Memorandum

To: Board of Selectmen, Arlington, Mass **From:** Transportation Advisory Committee **Subject:** Crosswalk at Norfolk and Jason

Reference: Board of Selectmen Letter: 15 July 2004

Photo 1. Approach southbound from Gray on Jason. Distance about 100 ft.

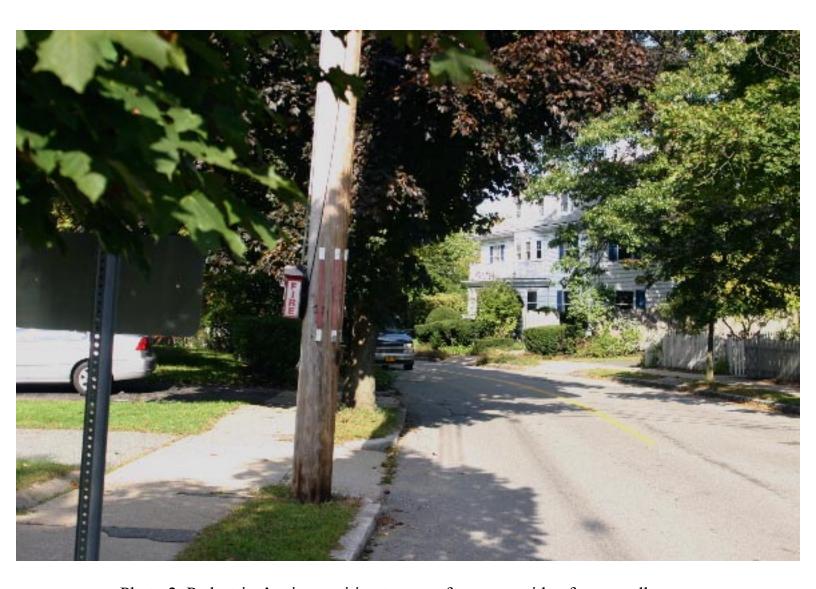
- a. Crosswalk is located within 80 100 ft of a curve traveling southbound on Jason. A pedestrian entering the crosswalk from the west can neither see nor be seen by southbound motorists until within that distance. See photos 1 and 2.

- a. Relocate the crosswalk to Woodland Street and the School Bus Stop, and all related signage to a location near Woodland Street.
 - i. Sight line there is straight with good view from both directions. (see photo 4)
 - ii. Crosswalk will be more equitably placed between Gray and Brantwood.
 - iii. Safety will be substantially increased, and mobility maintained.
